50-123
University of Missouri-Rolla
Nuclear Reactor Facility

This letter requests approval of a change in the organizational structure at the UMR Reactor Facility. Specifically, we would like to recreate the Reactor Director and Reactor Manager positions to replace the existing Reactor Director Position.

Attachment 2. Proposed Changes To Technical Specifications, Pages 37 and 38.

Figure 6-1. Organizational structure of the University of Missouri related to the UMR Nuclear Reactor Facility.

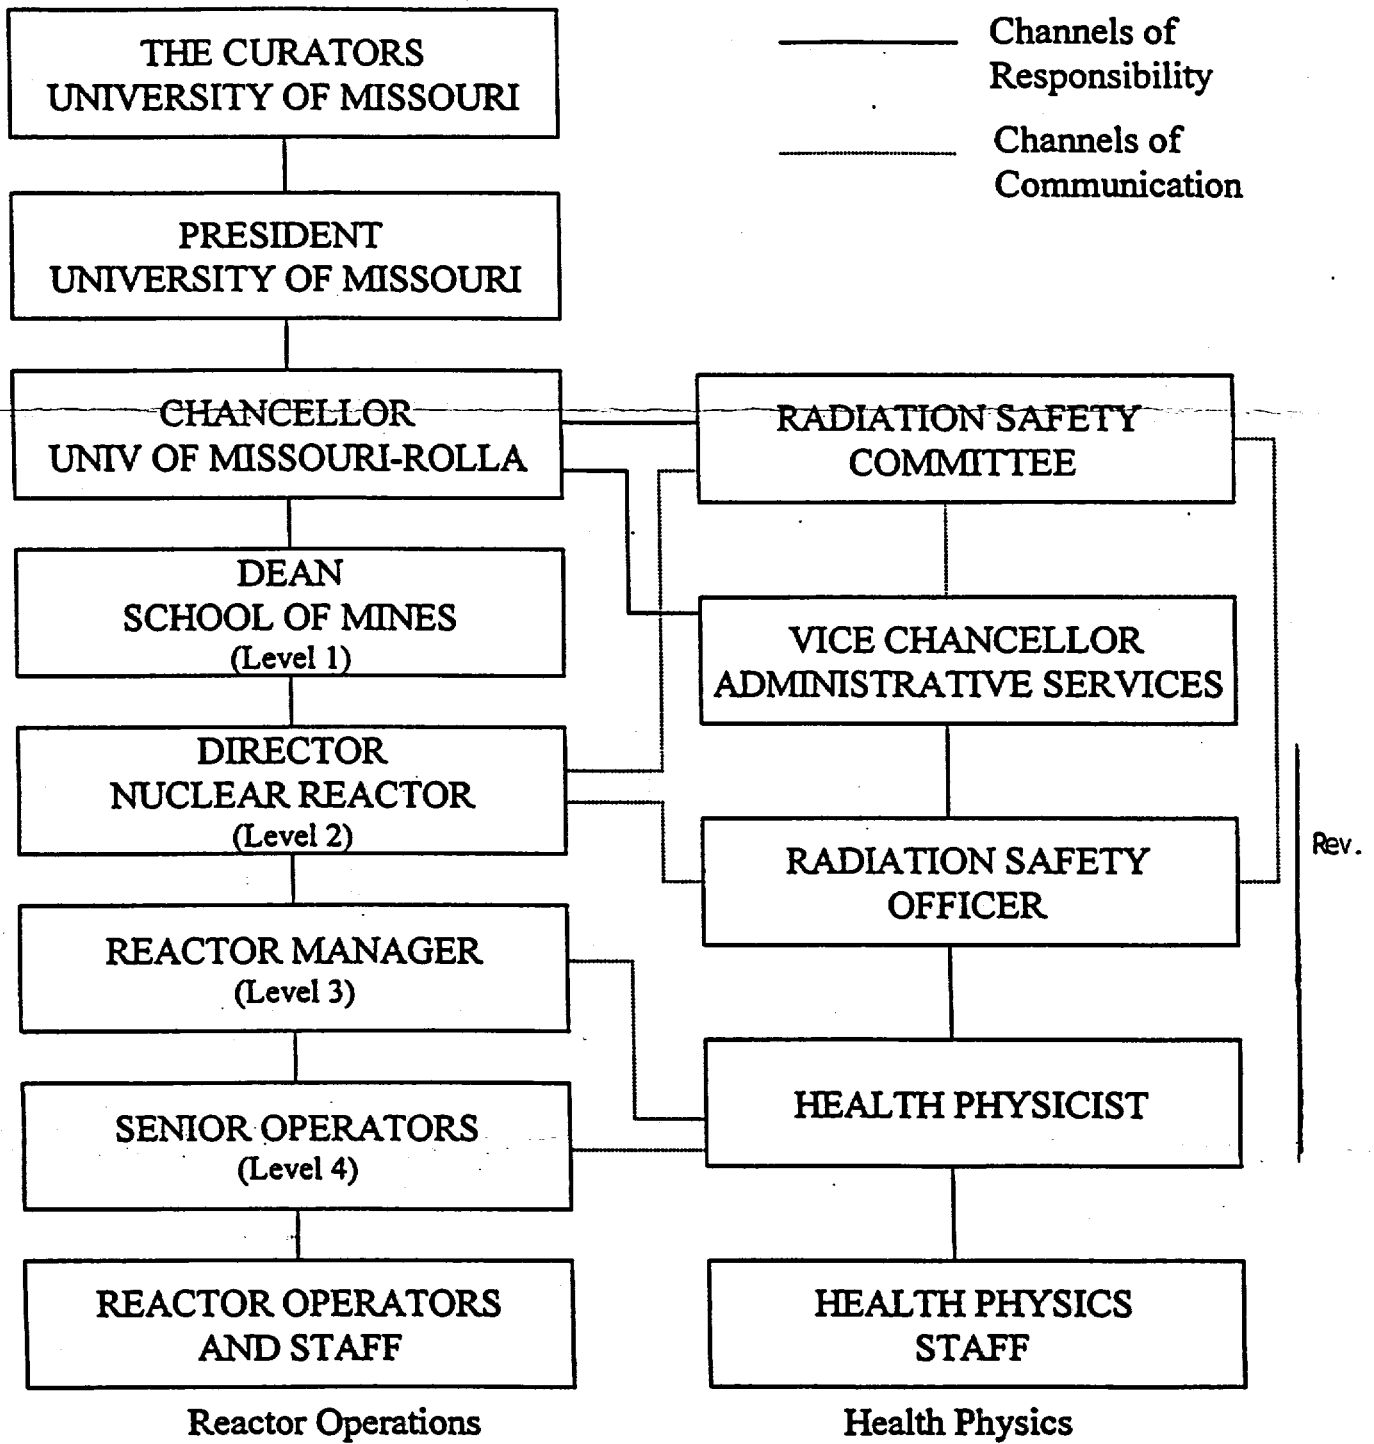
The proposed change involves the revision of pages 37 and 38 of the facility's Technical Specifications (see Attachment 2). In particular, the reference to the Reactor Manager position is added to the text and the organizational chart and minimum qualifications for the Manager have been stipulated. The requested change has been approved by the campus Radiation Safety Committee.

The Reactor Manager (Level 3) shall be responsible for the day-to-day operation and for ensuring that all operations are conducted in a safe manner and within the limits prescribed by the facility license and the provisions of the Radiation Safety Committee. During periods when the Reactor Manager is absent, his responsibilities may be delegated to a Senior Operator (Level 4).

The Reactor Manager shall have three years of nuclear related experience. A maximum of two years equivalent full-time academic training may be substituted for two of the three years of nuclear related experience required. As soon as reasonably possible after being assigned to the position, the Reactor Manager shall obtain and maintain a NRC Senior Operators license.
